SUBJECT CEA 3322 - MCB BENZENE
REDUCTION INTERIM COMPLIANCE

MCB Benzene Reduction
Interim Compliance,
12-12-78

CEA 3322 - MCB BENZENE REDUCTION
INTERIM GUIDELINE COMPLIANCE

FIGURE I
MAXIMUM DOWNWIND CONCENTRATIONS
FROM A SPILL OF PURE BENZENE

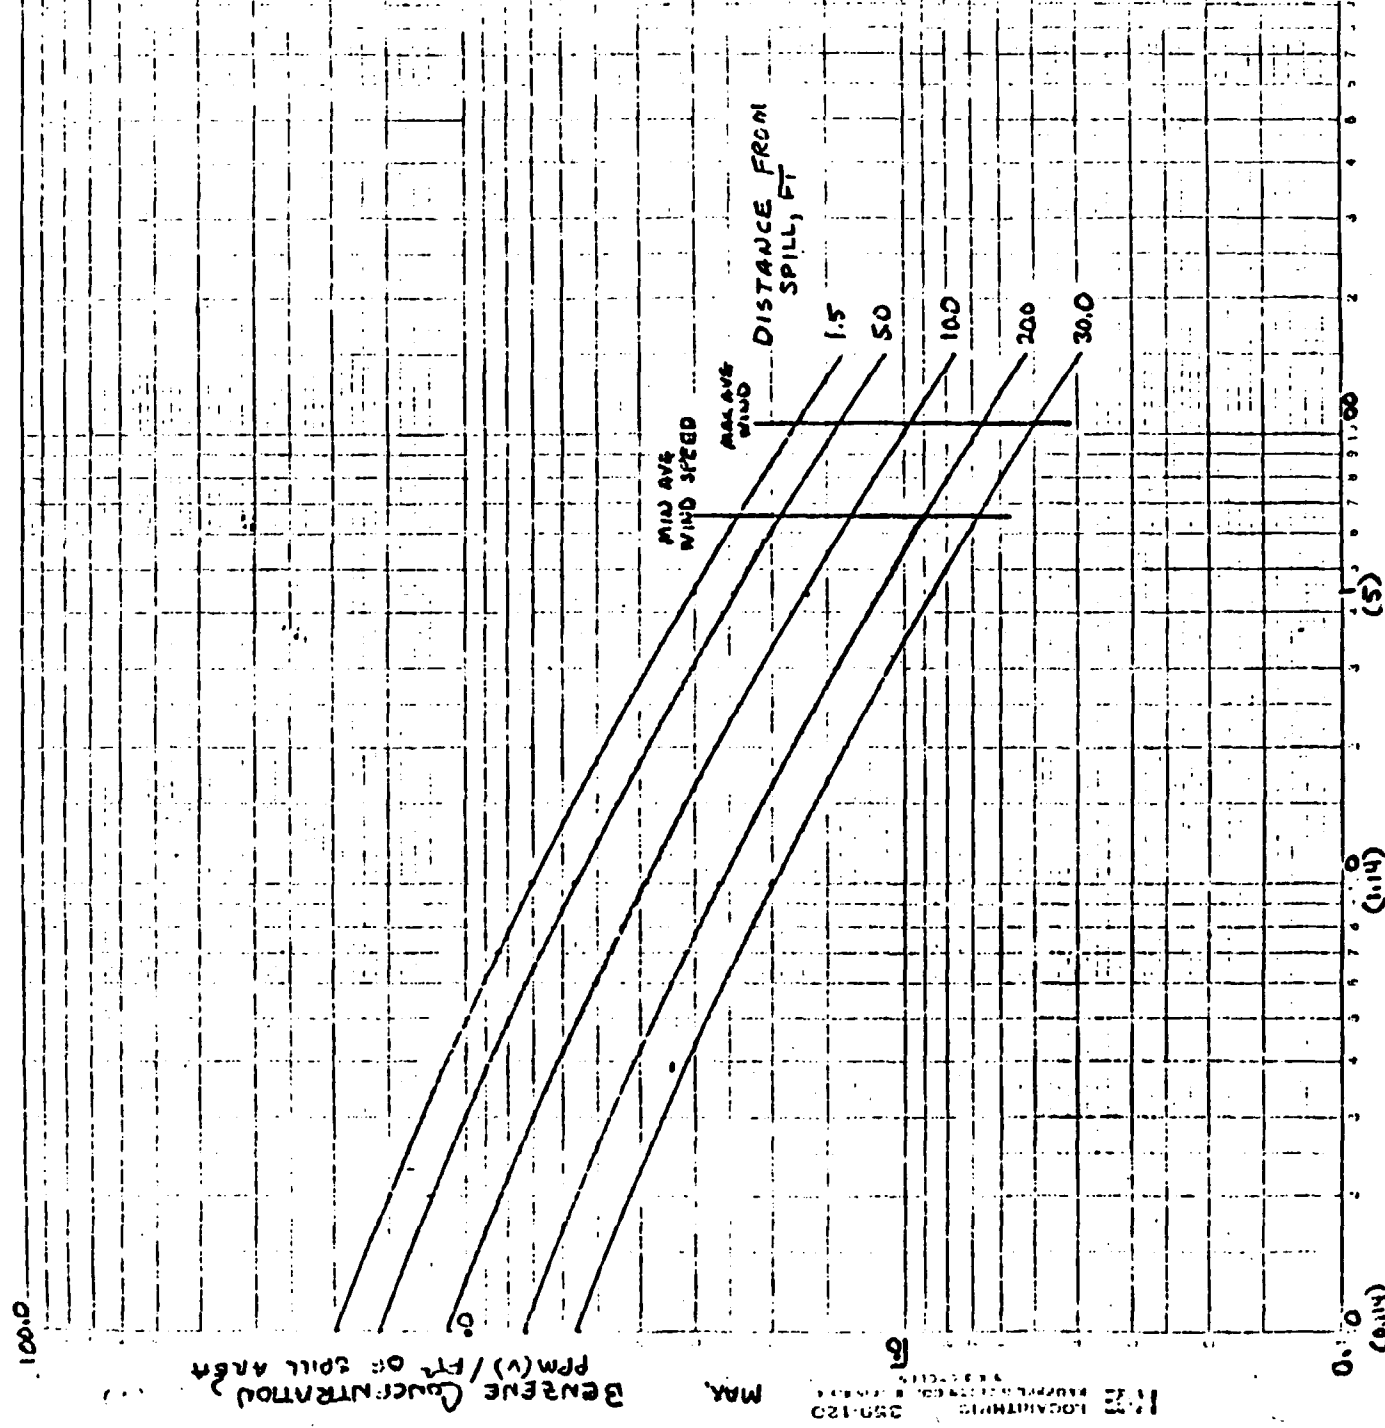
Figure I in the Appendix shows the exposure possible from a benzene spill of 1 ft.². Under stagnant wind conditions of 1 mile per hour wind speed, a spill of less than 3 ft.² will exceed the 20 ppm ceiling limit within 5 ft. of the spill.

Recommendation: Paving and curbing should proceed as part of CEA 3322. Install only if the decontamination system is installed.
